FLOOR PLAN — REV Q

REV Q · 22 SEP 2026 9:27 AM · EAST END CONFIRMED BY LIDAR
ANCHORED ON THE 12×24 GARAGE

I FOUND THE TOILET — AND IT CONFIRMS THE WHOLE EAST END

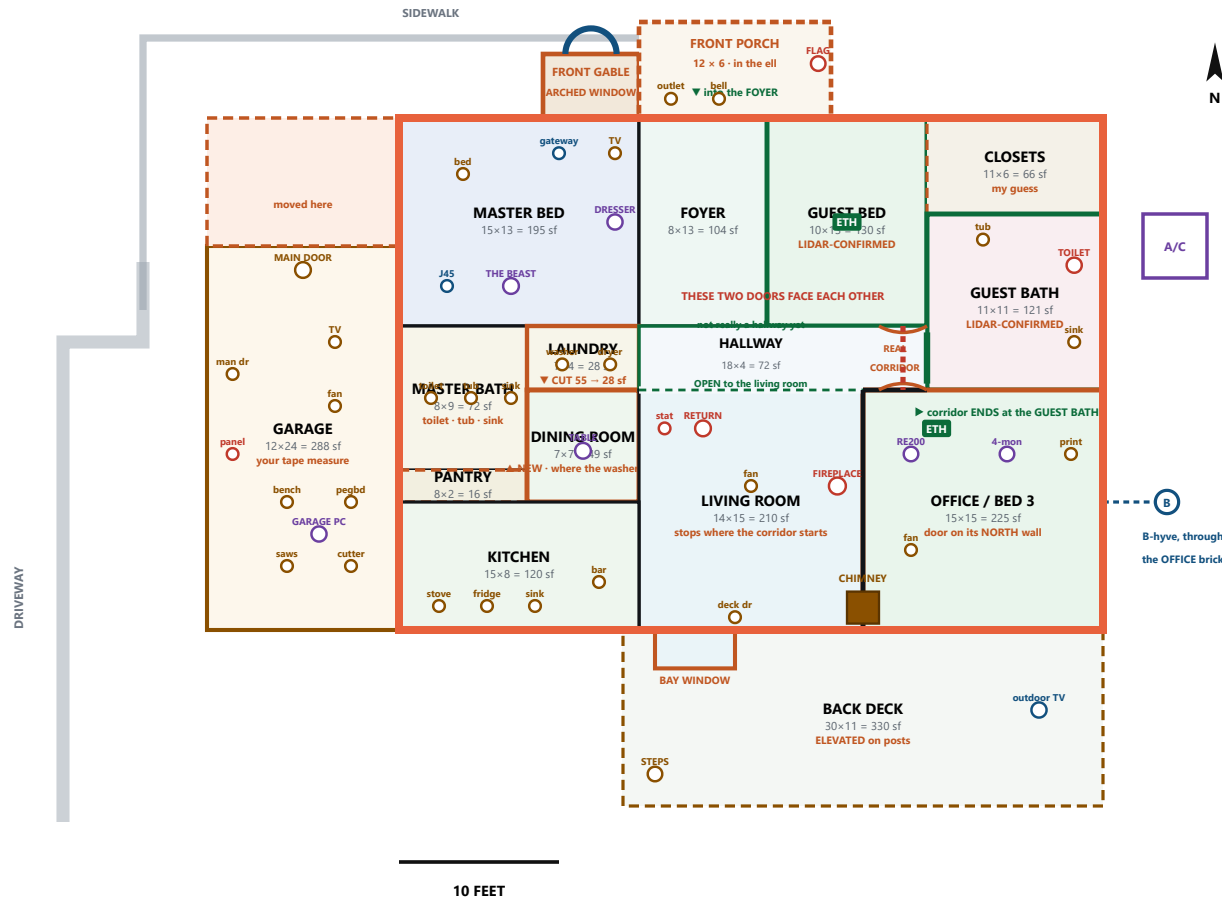
It is there, and it is decisive. On the east side of room6 the mapped floor wraps a **stepped diagonal**. A **straight wall maps as a straight line**; a staircase like that is the robot tracing something **round**, quantised into grid cells. That is a toilet base, on the **east wall**.

And it tells me which half of room6 is which. You said the map draws the guest bedroom and guest bathroom together, so: the **lobe running NORTH off the corridor is the GUEST BEDROOM**, and the **east lobe, the one with the toilet, is the GUEST BATHROOM**.

Toilet drawn on the guest bath's **east wall**, tub on the north where your pen circled it, sink below.

At 9:25 you said “where the red walls are is where the hall is a real hallway”, so I pulled the two dashed runs out of the image by colour — 187 px and 214 px against a 1,172 px house — called it **16–18% of the width, so 7 to 8 feet**, and stretched the corridor from 4 ft to 8 ft on that basis.

Then you said those walls are just there to keep him out of the office and guest bedroom, and are not to scale. So the number is worthless and I have reverted it. The corridor is back to the **4 ft the room geometry itself gives** — it is exactly as long as the guest bedroom and the office overlap, which is a derived length, not a guess.

For those two doors to face, the office has to come WEST far enough to reach the hall, and the living room has to stop short of it. That is the piece I kept missing. And it is the same thing you told me at 9:01 — **“it’s not really a hallway until the living room ends.”** The living room ending IS where the corridor starts. Those two sentences are one instruction.

✓ **9:11 AM — “the laundry room is way too big; the dining room and dining room table need to be where the washer is.”** Done, and it re-cuts that whole west block: **LAUNDRY cut from 55 sf to 28** (7 × 4, washer and dryer side by side on the north wall), and a **DINING ROOM, 7 × 7 = 49 sf,**

now stands where the washer used to be with the table in it. The kitchen is just **KITCHEN** now — dining is its own room, which is also what the duct scope always said: it lists “**dining room**” as its own 6" → 8" run, separate from the kitchen. Master bath and pantry re-proportioned to suit. **The block still totals 285 sf, so the house is still exactly 1,408.**

- **OFFICE / BED 3 is now $15 \times 15 = 225$ sf**, the southeast quarter — it reaches west to the corridor and east to the brick.
- **LIVING ROOM $14 \times 15 = 210$ sf**, stopping at the corridor.
- **GUEST BATH moved south** to 11×11 , so the corridor can run into it.
- **CLOSETS** — an 11×6 block left over at the northeast. **That is my guess at what fills it**, and it is the one piece of the 1,408 I cannot source to something you have said. **Tell me what is really there.**

Your orange put the office's top-left corner up at the hallway band. I have it one band lower, at the corridor. **If I put it where the orange is, the office and the guest bed touch only at a single corner and their doors cannot face each other** — which is the thing you have now told me twice. **I followed the sentence over the highlighter.** If the orange is right and I have misread the sentence, say so and I will put it back.
